Entergy Nuclear Operations, Inc.
(Indian Point Nuclear Generating Units 2 and 3)

AP1000 Draft Safety Evaluation Report LBB Open Items

Presentation to NRC Staff
Rockville, MD

July 11, 2003

Figure 8.6.1 AP1000 Bounding Analysis Curve for 8" CMT DVI IRWST
(Line Numbers: L015A,016A,018A,020A,021A-No Insul.,025A,125A,127A)

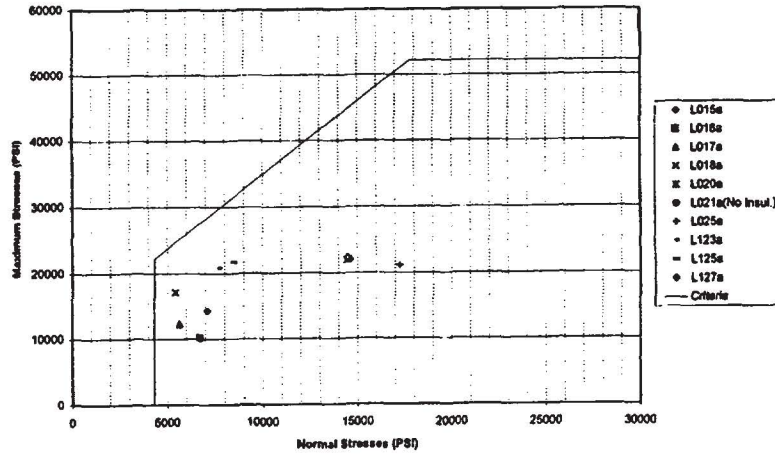
- **Piping stress analysis for AP1000 candidate system in-progress**
- **DVI-A Piping Analysis Package**
 - Selected based on our experience with AP600
 - Difficult to qualify
 - Complicated piping system
 - Some piping sizes were changed
 - Contains smallest piping line qualified for LBB
 - Subcompartment pressurization impacts if line would not meet LBB criteria

- **SECY-02-0059 Approved DAC Approach for Piping**
 - Design Acceptance Criteria in lieu of detailed piping design and analysis
- **W approach specifies that piping stress analysis be completed as part of COL application**
- **AP600 piping stress analyses can be used to demonstrate feasibility for AP1000**
- **AP1000 piping stress analysis for DVI-A further demonstrates feasibility**
- **No additional piping analysis required**
